TM/C5394/13458

Re: Star Academy, Radcliffe (Temporary Accommodation) – Letter response to Bury Council

We write in response to Bury Council letter reference CL295.210824.1 dated 22nd August 2024 written by Rebecca Jones, Environmental Protection Officer at Bury Council. The letter was produced after the Environment Section received a copy of the following report which was submitted in support of discharge of condition 5 of Bury Council Planning Permission ref. 70002:

Drawing Title
EXTERNAL SERVICES LAYOUT

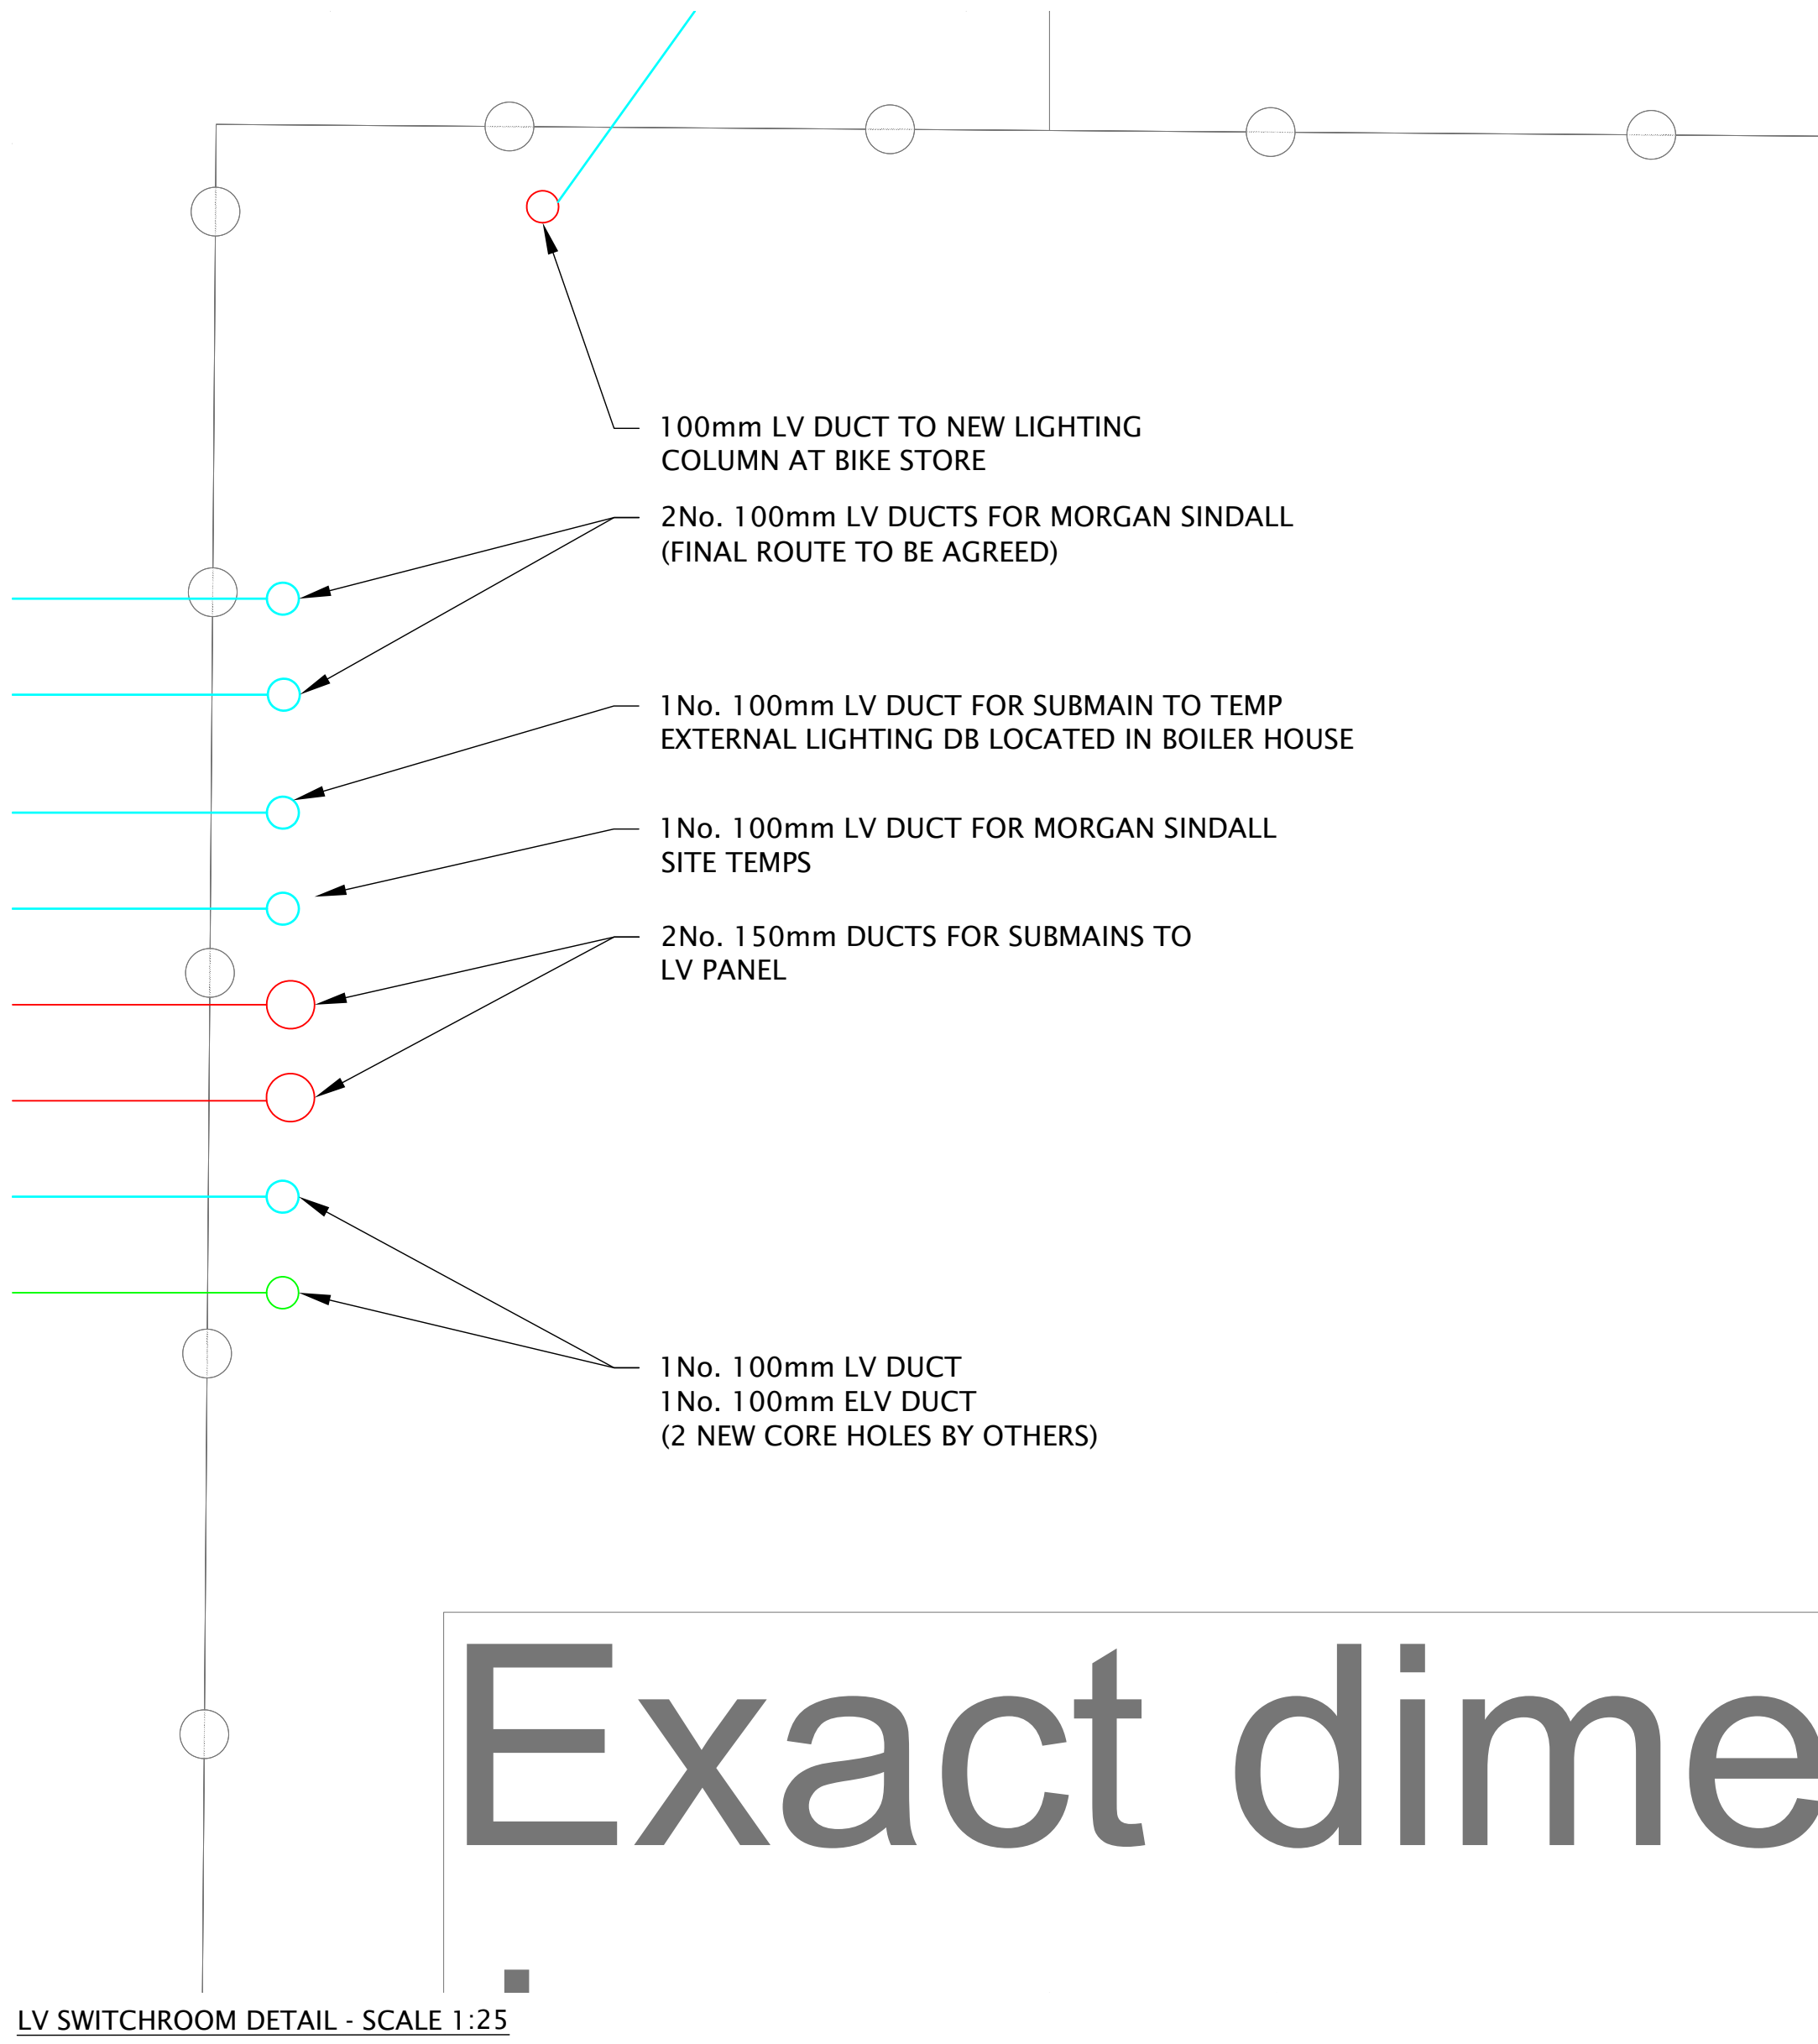
3. With respect to the potable water supply pipe, no information regarding this action was included in the Validation Report. A copy of the United Utilities water supply pipe risk assessment has been requested. Where barrier pipe is needed, validation information including photographic evidence and receipts/delivery notes for the barrier pipe has been requested.
-

However, as detailed in the Temporary Accommodation Proposed External Services Layout drawing, ref. FS1013-KRD-EX-XX-D-Z-9002 rev P05, the water supply for the temporary accommodation building is drawn predominantly from an existing water main running northwards from Spring Lane towards the north-eastern corner of an existing sports pitch on site. The only new services installed as part of the temporary accommodation are a new water meter at the connection point and a new polyethylene water pipe feed linking the new meter and the temporary accommodation. Given the temporary nature of the new building, which is only anticipated to be open for 18 months while the new permanent school is constructed, the installation of barrier pipe is considered highly onerous as the PE pipe which has been installed is highly unlikely to undergo any significant degradation over this short time period. In addition, given the majority of the length of the water supply is utilising existing service runs, the installation of barrier pipe over the short distance between the meter and the new temporary building would likely be ineffective and consideration is also given to the fact that the existing water main has served the former school and leisure centre for many years with no reports of ill health.

The Temporary Accommodation Proposed External Services Layout drawing is presented in Appendix D, alongside a photographic record of the installation of the limited section of new underground water supply to the west of the temporary accommodation building.

On the balance of risk and given the factors discussed above, the potential for exposure to contaminants within the made ground via the potable water supply pipe is considered to be very low to negligible due to the temporary nature of the new building which is only expected to be open for a

period of 18 months. BSL can confirm that barrier pipe will be used for the entire length of the new services being installed as part of the new permanent school development.
